Davis-Besse Nuclear Power Station  
Docket No. 50-346, License No. NPF-3  
Response to Request for Additional Information on 10 CFR 50.55a Request RR-A35,  
Proposed Alternative to System Leakage Test Requirements (TAC No. ME6056)

Response to 11/3/11 Request for Additional Information on Request RR-A35, Proposed Alternative to System Leakage Test Requirements

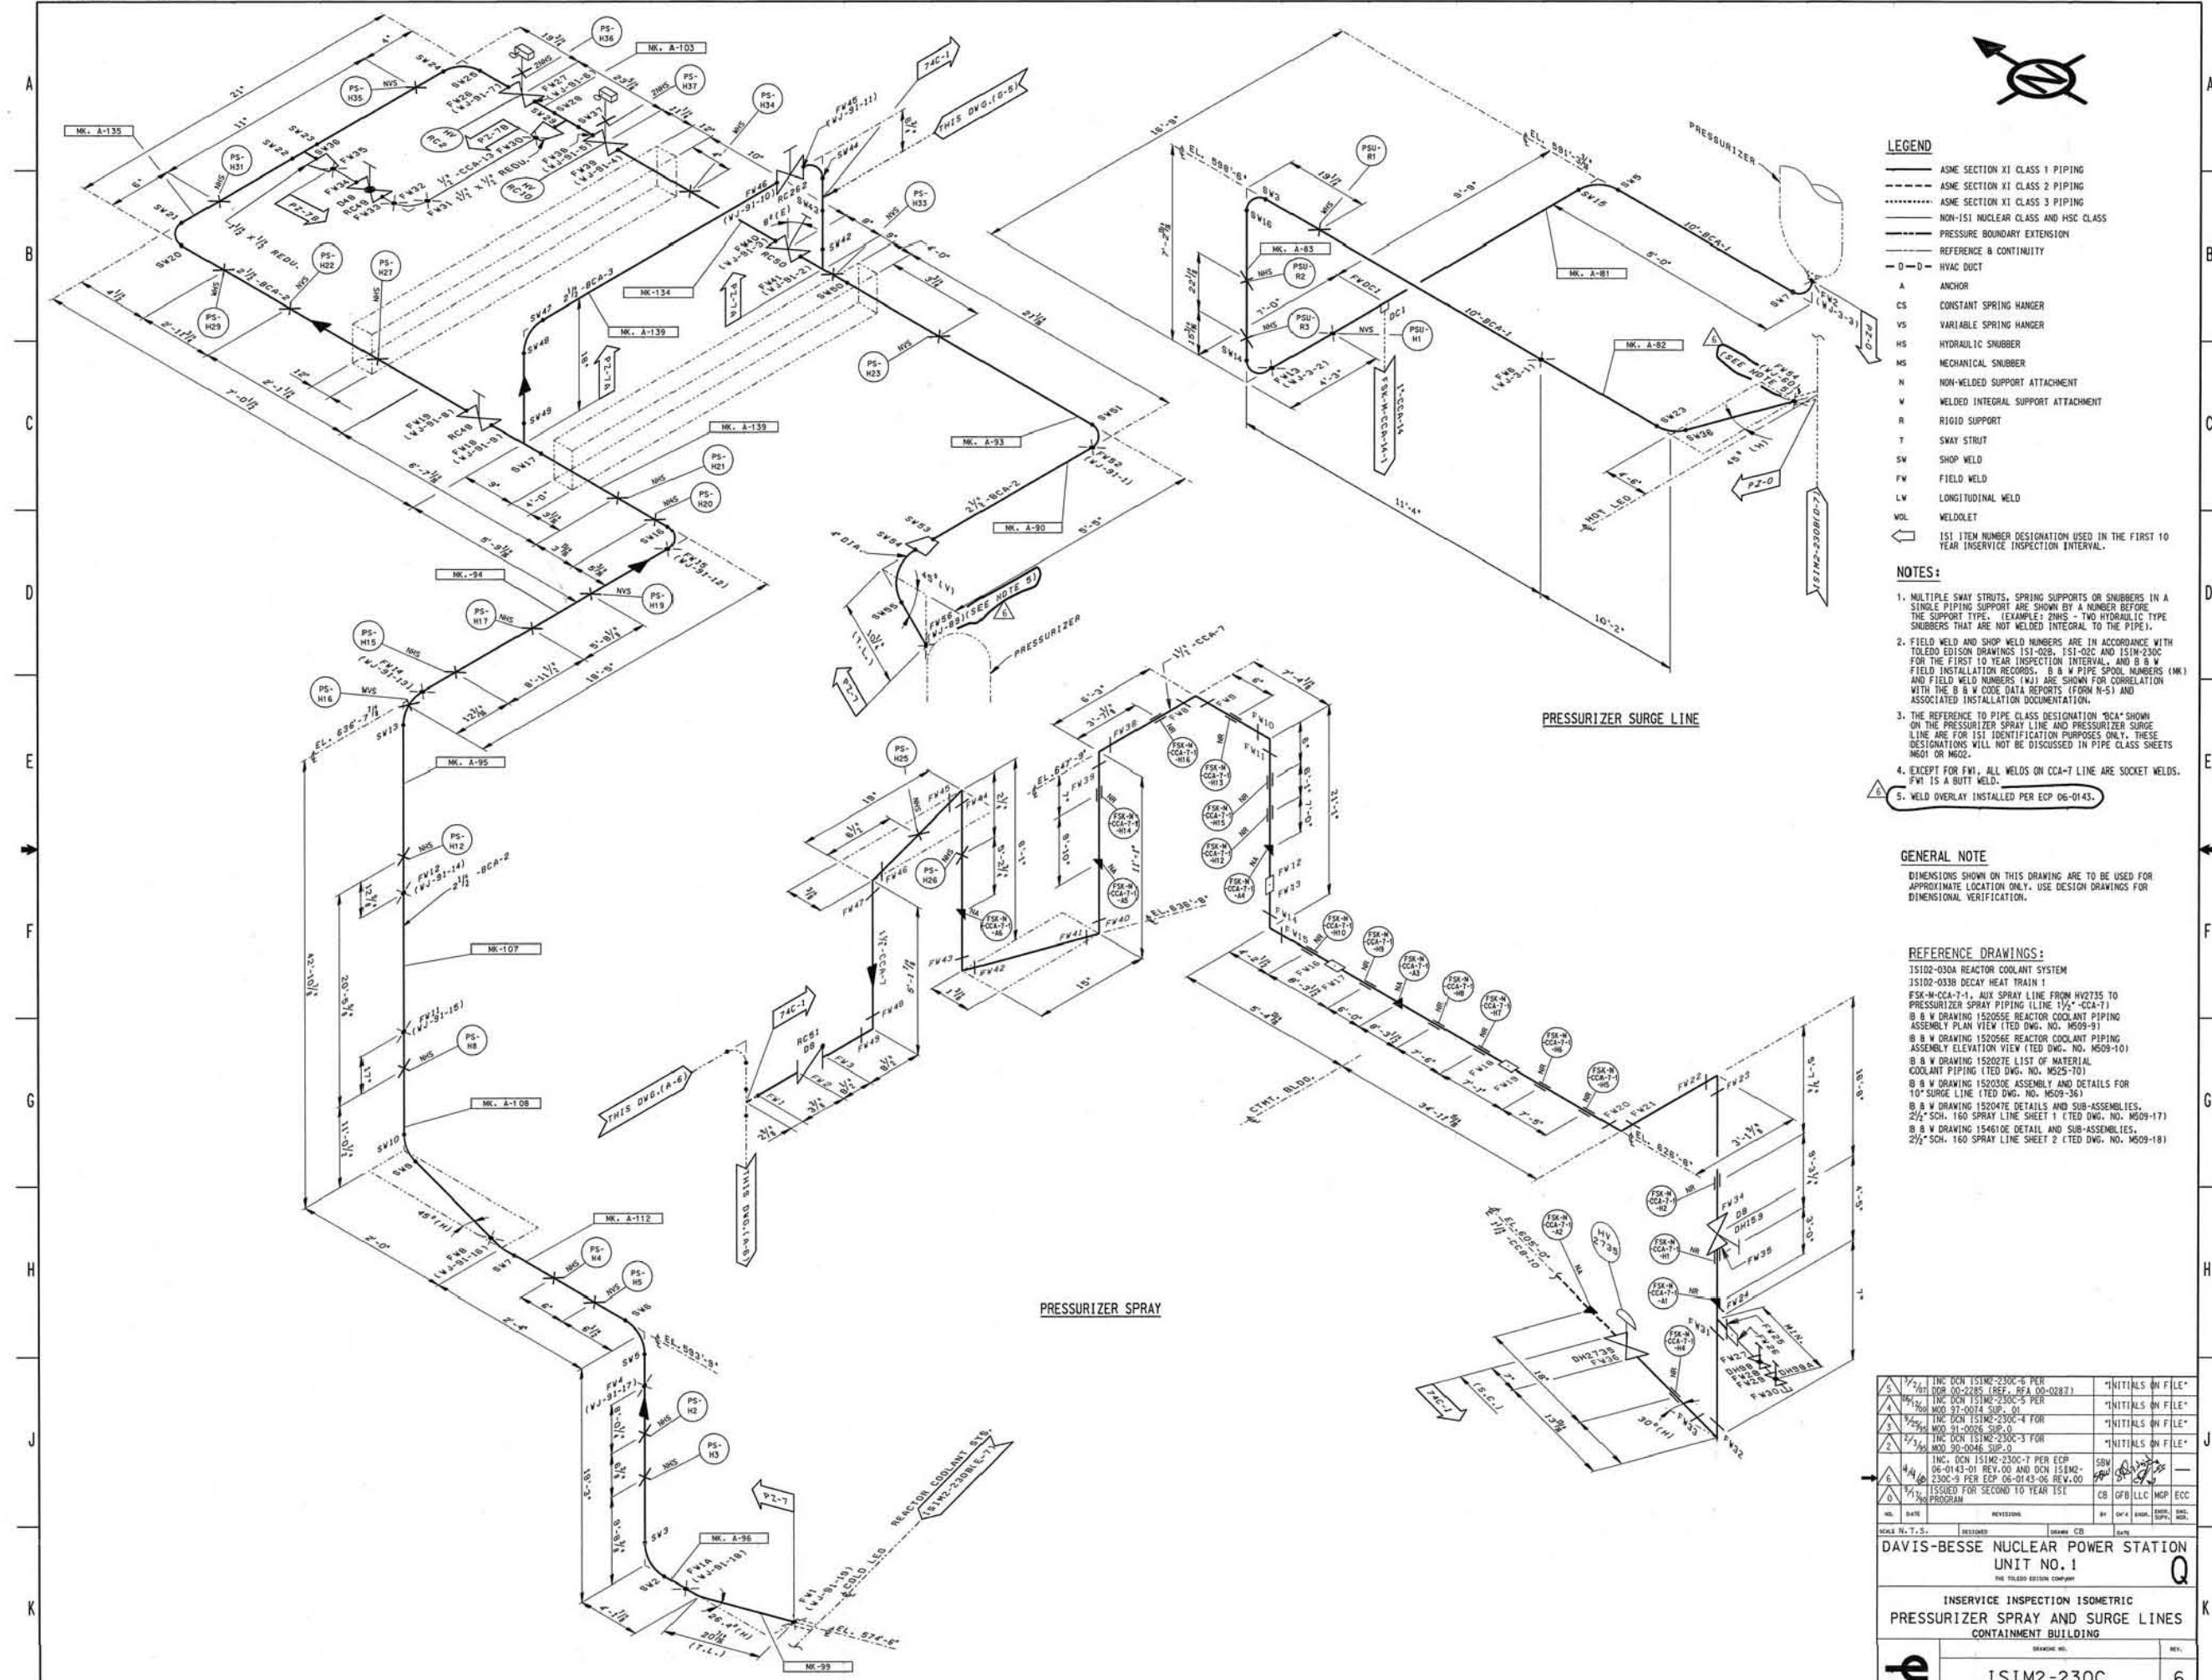
**1. For the subject auxiliary pressurizer spray system Test Zone DH16:**

**a. Provide a piping and instrumentation diagram and a piping isometric drawing.**

The examination boundary for Test Zone DH16, Pressurizer Spray Line, is from valve DH2735 to valve RC51. Piping and instrumentation diagrams are provided as Enclosures A and B. The piping isometric drawing is provided as Enclosure C.
